Work Order ID 144238

Item Name: Basket Hoop

DESIGN #	DRAWN BY CP	DART AEROSPACE LTD HAWKESBURY, ONTARIO, CANADA	
CHECKED #	APPROVED #	DRAWING NO. D3166	REV. A SHEET 1 OF 1
DATE 02.07.10		TITLE BASKET HOOP	SCALE NTS
A	02.07.10	NEW ISSUE	
A1	04.04.08	38+/-1 WAS 36.0

DRAWING NO. D3166	TITLE BASKET HOOP	REV A1	DART AEROSPACE LTD ENGINEERING ORDER		D.E.O. NO. D3166-A-2	SHEET NO. 1 OF 1	SCALE NTS
DRAWN AJS	CHECKED <i>[Signature]</i>	MFG. APPR. <i>[Signature]</i>	APPROVED <i>[Signature]</i>	DE APPR. <i>[Signature]</i>			
DATE 08.12.11	DATE 08.12.15	DATE 08/12/15	DATE 08/12/16	DATE 08.12.16

D3166-1 BASKET HOOP

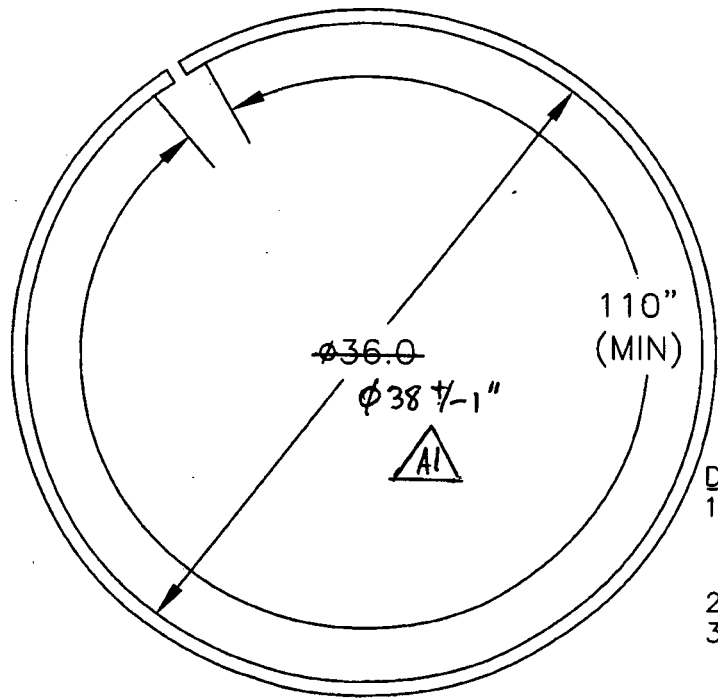
1) MODIFY MATERIAL NOTE FOR D3166-1 AS SHOWN:

WAS:

- 1) MATERIAL: AISI 304/316 SS SQUARE TUBING,
0.75" x 0.75" x 0.063 WALL, 60.00" LONG
(REF DART SPEC. M304TS0.750W.063)

2) MODIFY MATERIAL NOTE FOR D3166-3 AS SHOWN:

WAS:

- 1) MATERIAL: AISI 304/316 SS SQUARE TUBING,
0.75" x 0.75" x 0.063 WALL, 120.00" LONG
(REF DART SPEC. M304TS0.750W.063)

IS:

- 1) MATERIAL: AISI 304/316 SS, 3/4 X 3/4 X 0.065 WALL SQUARE TUBING,
60.00" LONG
REF. DART SPEC M304TS0.750W.065

IS:

- 1) MATERIAL: AISI 304/316 SS, 3/4 X 3/4 X 0.065 WALL SQUARE TUBING,
120.00" LONG
REF. DART SPEC M304TS0.750W.065
